**Economic and Social Council**Distr.: General  
10 July 2019

**World Forum for Harmonization of Vehicle Regulations****Working Party on Automated/Autonomous and Connected Vehicles\*****Fourth session**

**UN Regulation No. 79:****Automatically Commanded Steering Function****Proposal for a Supplement to the 03 series of amendments  
to UN Regulation No. 79 (Steering equipment)****Submitted by the experts from the International Organization of Motor  
Vehicle Manufacturers and European Association of Automotive  
Suppliers \*\***

**ACSFC – Case where the lateral movement is initiated automatically (1 Step HMI)**

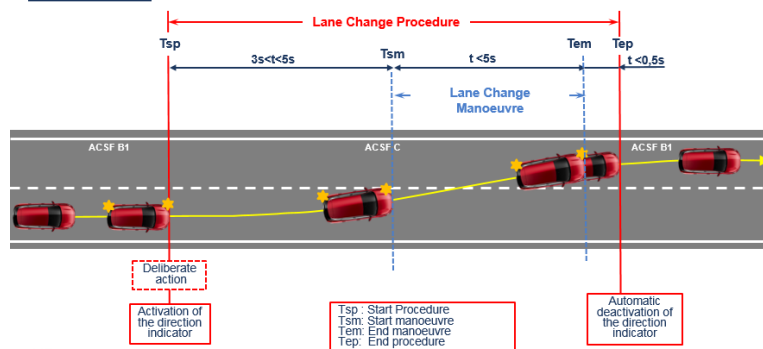
The lane change manoeuvre shall not be initiated before a period of 3.0 seconds and not later than 5.0 seconds after the deliberate action of the driver described in paragraph 5.6.4.6.2. above.

The lane change manoeuvre shall be initiated either automatically or by a second deliberate action of the driver. A vehicle shall not be equipped with both these means of initiation.

In case of an automatic initiation the lane change manoeuvre shall commence between 3.0 seconds and 5.0 seconds after the manual activation of the procedure as described in paragraph 5.6.4.6.2. and shown in the Figure below.

**ACSFC – Case where the lateral movement is initiated by a second deliberate action by the driver (2 Step HMI)**

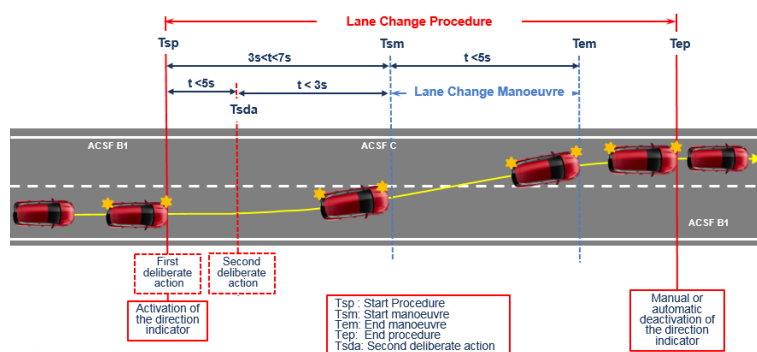
In case of an initiation by a second deliberate action the lane change manoeuvre shall commence between 3.0 and 7.0 seconds after the manual activation of the procedure as described in paragraph 5.6.4.6.2.

Additionally, the lane change manoeuvre shall commence at the latest 3.0 seconds after the second deliberate action as shown in the Figure below.
